Section 75W Modification (MP07_0106) Concept Plan Modification

Clemton Park Village

Concept Plan Modification (Mod 6)

Submitted to Planning & Infrastructure
On Behalf of Australand Holdings Pty Ltd

Figure 2 – Envelope Study comparing the likely approved and proposed building envelopes (looking west)

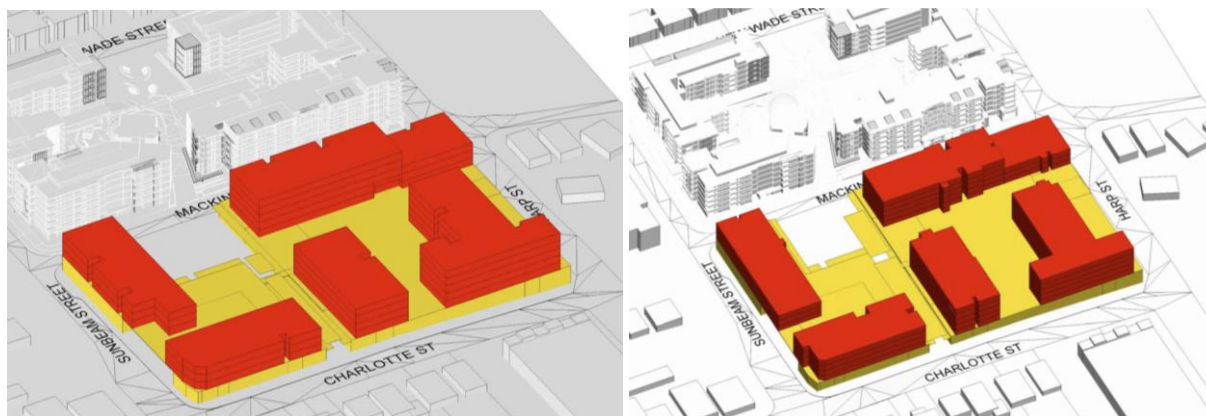
As a result of the GFA transfer, the building heights in Buildings 2 and 3 of Proposed Lot 42 (shown in **Figure 2**) will increase by one storey each. This will result in a height of:

- Building 2: 4 Storeys (above podium) at the corner of Sunbeam Street and Charlotte Street; and
- Building 3: 5 Storeys (above podium) on Charlotte Street.

An envelope study prepared by Group GSA, comparing the envelopes created by the Concept Plan approval (Mod 4) and the Proposed Lot 42 envelopes are shown at **Figures 3 and 4** from two different perspectives, and provided at **Appendix B**.
